**To:** Steve Adams, PE and Dennis Egner | City of Milwaukie, Oregon

**From:** Kirk Paulsen, PE and Adrian Esteban, PE | Alta Planning + Design

**Date:** November 7, 2019

**Regarding:** Monroe Street Greenway Alignment Options for the McFarland Property

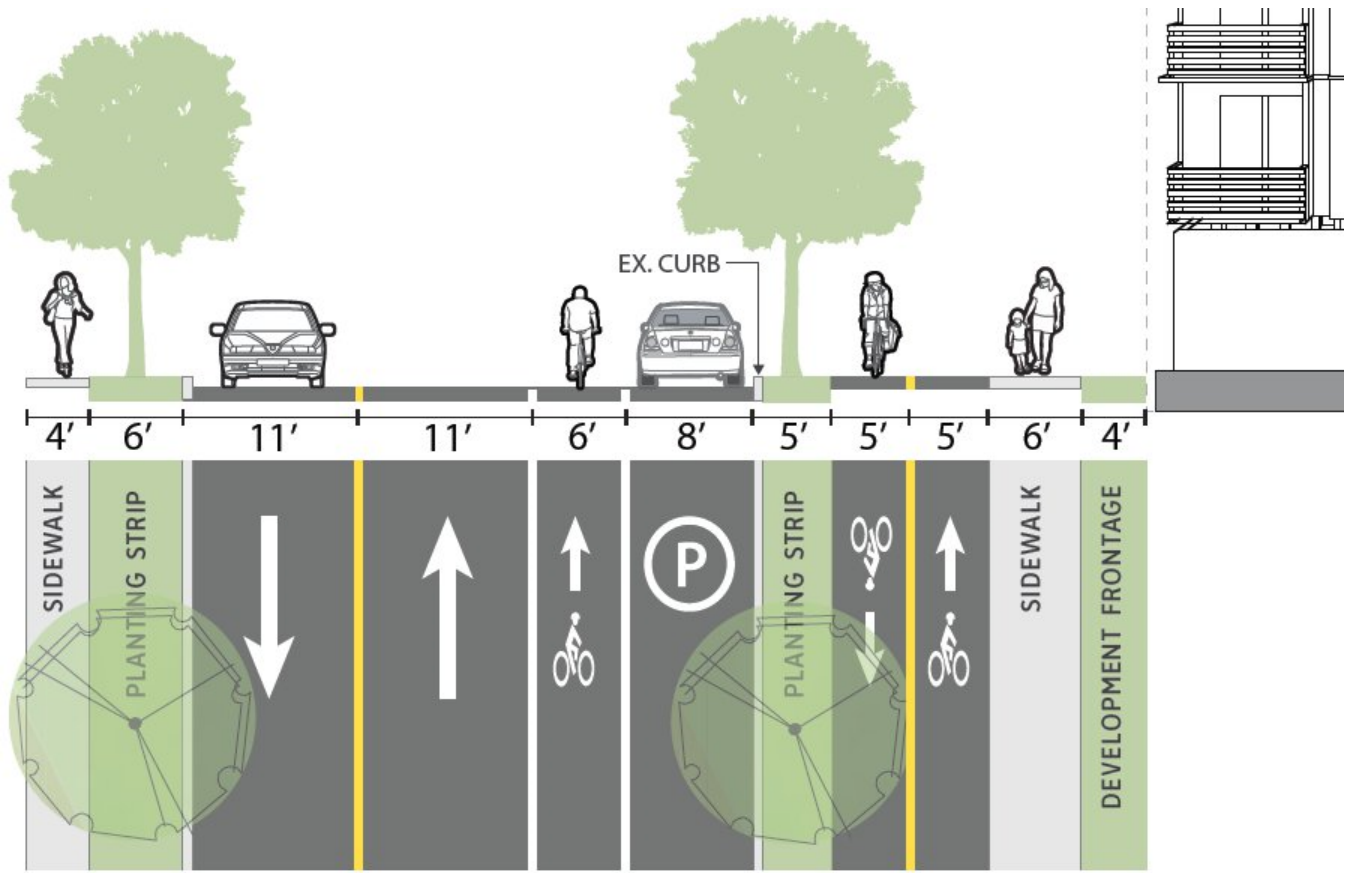
The proposed trail alignment would be a 10' wide shared use path (SUP) located within a 15' easement between the rail corridor and the southern boundary of the proposed development, providing a direct connection between Oak and 37th. The trail option would be free of conflicts with motor vehicles and, by this metric, would be considered to be a low-stress segment of the greenway route.

It should be noted that this alignment option has been proposed as part of the development in conjunction with standard painted bike lanes along both Monroe and 37th.

**Sidewalk Level 2-Way Bike Facility Concept (Street Alignment Option A)**  
 Monroe St between Oak St and 37th Ave (Looking East)

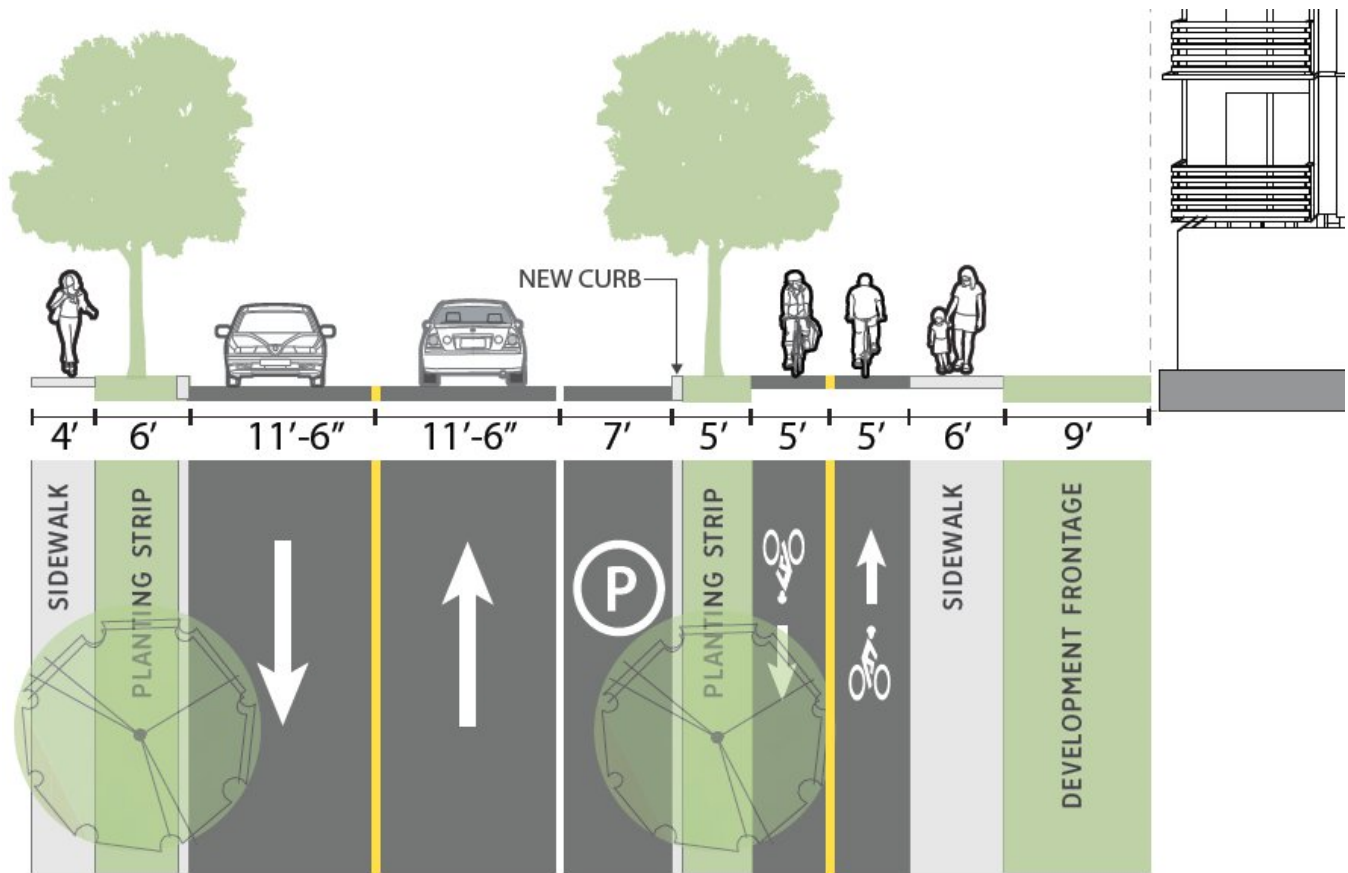
One variation of the design ('Option A') would utilize the existing southern curb along Monroe, shown in the cross section on the following page. Retaining the existing curb-to-curb width of Monroe would allow for an eastbound bike lane to be provided in the uphill direction for people who desire to continue biking along Monroe at street level. The downside of this option is that the distance between buildings of the proposed development and the sidewalk would be about 4', less than the current design assumption of 9'. As the City of Milwaukie Planning Department staff have observed, a 4' setback would minimize the functional setback of the building. Additionally, the planned sidewalk is already within the 15' easement. The Planning Department strongly prefers to retain the 9' distance between the buildings and the sidewalk.

**Sidewalk Level 2-Way Bike Facility Concept (Street Alignment Option B)**  
 Monroe St between Oak St and 37th Ave (Looking East)

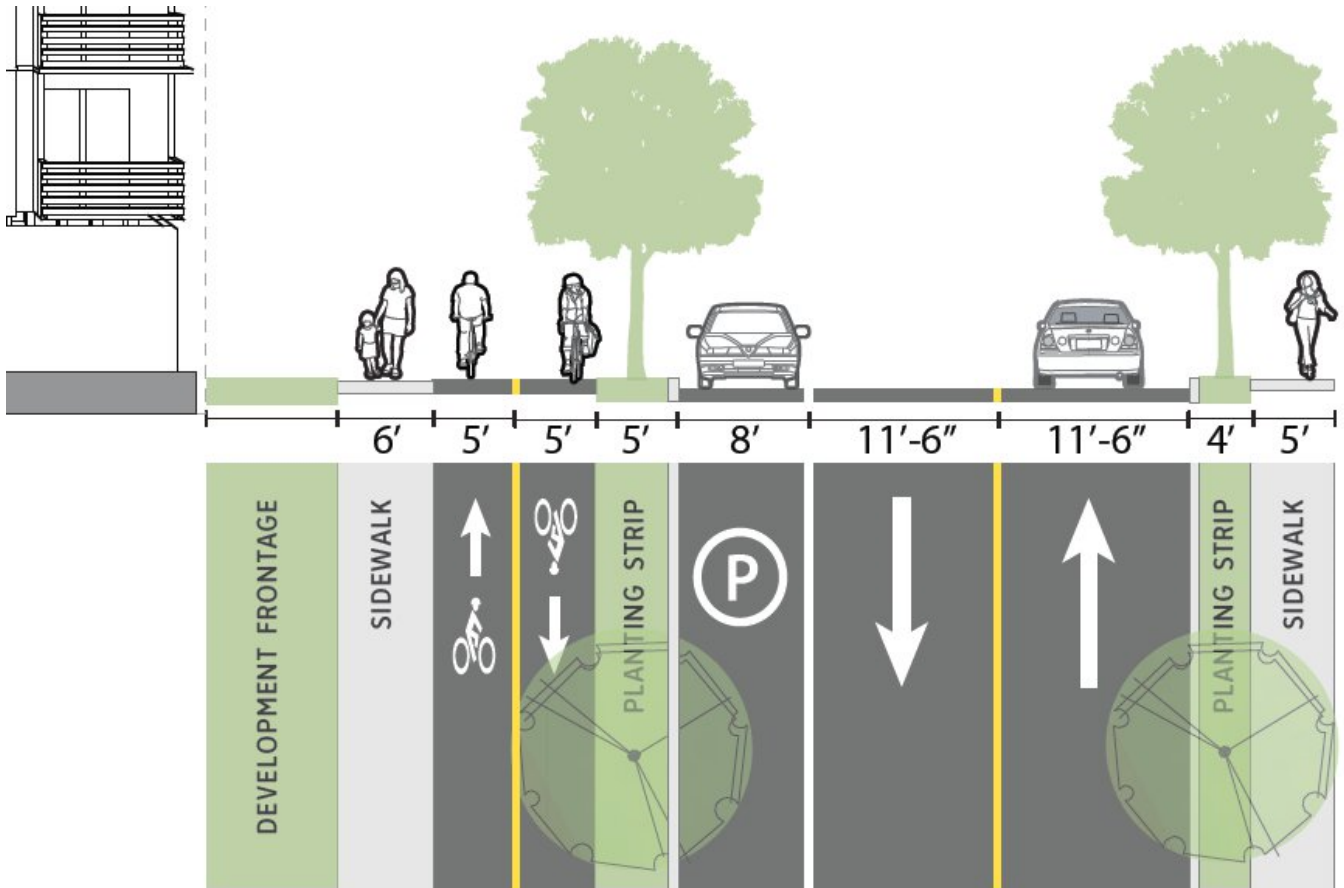
The other variation of the design ('Option B') would retain the distance of about 9' between the buildings of the proposed development and the future sidewalk by not providing a street-level uphill bike lane, therefore narrowing the curb-to-curb width of Monroe. A cross section of this variation along Monroe is shown on the following page. While this option would more closely match the most recently proposed design of the development, the biggest downside is that it would introduce a gap in the on-street bike lane network along Monroe in the uphill direction, affecting people who desire to continue biking along Monroe at street level. Another downside is that the southern curb along Monroe would need to be fully reconstructed, increasing the costs of this option as compared to 'Option A'.

Both street alignment options would not provide a painted westbound bike lane along Monroe, as compared to the recent development proposal. In addition, both options would also require minor realignment of travel lanes east of 37th, resulting in the loss of some on-street parking spaces.

**Sidewalk Level 2-Way Bike Facility Concept (Street Alignment Options A & B)**  
 37th Ave between Washington St and Jefferson St (Looking North)

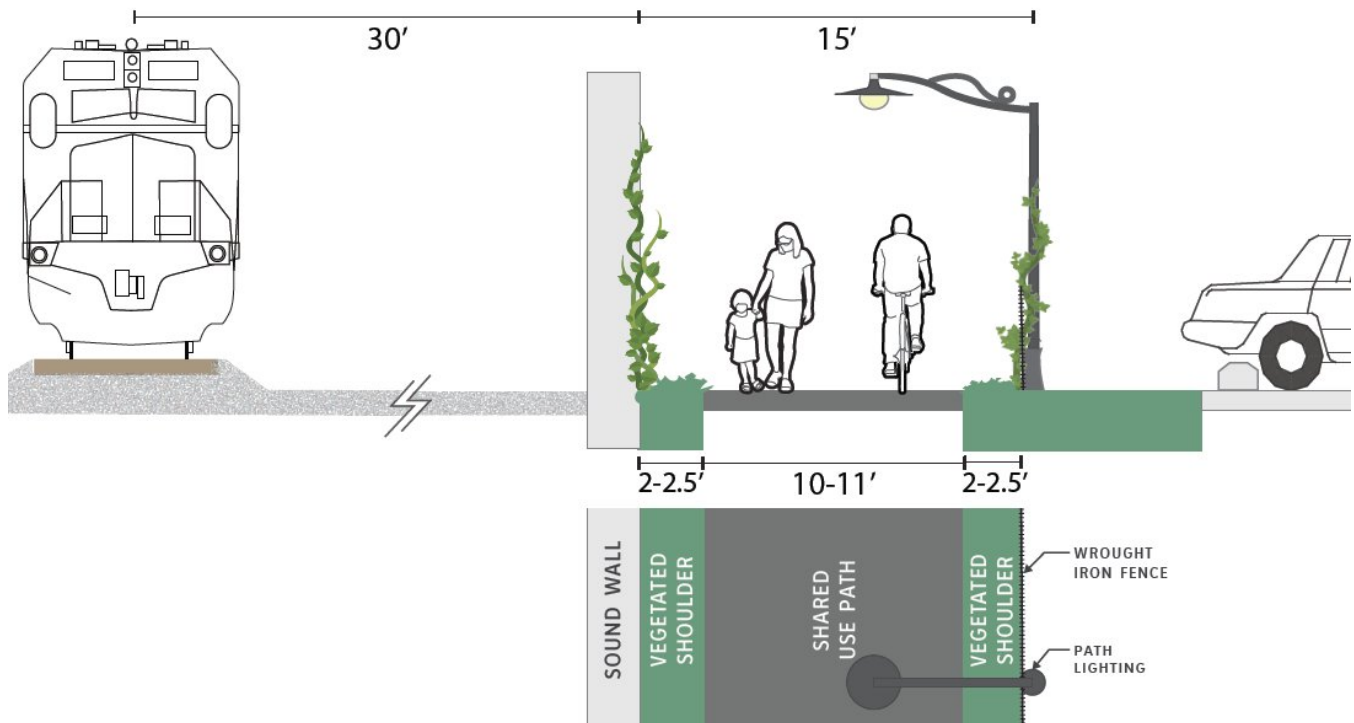
Both variations of the proposed greenway facility would result in the same cross section along 37th, shown on the following page. The main difference between this option and the current design of the proposed development is the inability to retain the existing curb at the SW corner of the intersection of 37th at Monroe. The 3-lane intersection approach would transition to 2 lanes at SE Jefferson, at which point on-street parking spaces along the west side of 37th can be defined with the use of a curb extension. On-street parking would not be allowed north of SE Jefferson as is currently proposed. In addition, the recommended street alignment option would not provide painted bike lanes along 37th, as is reported to be the case for the recent development proposal.

Note: the western edge of the west sidewalk shown on the following page would match the location of sidewalk proposed within the most recent development plans. The eastern curb of 37th as shown below reflects the location of existing curb.
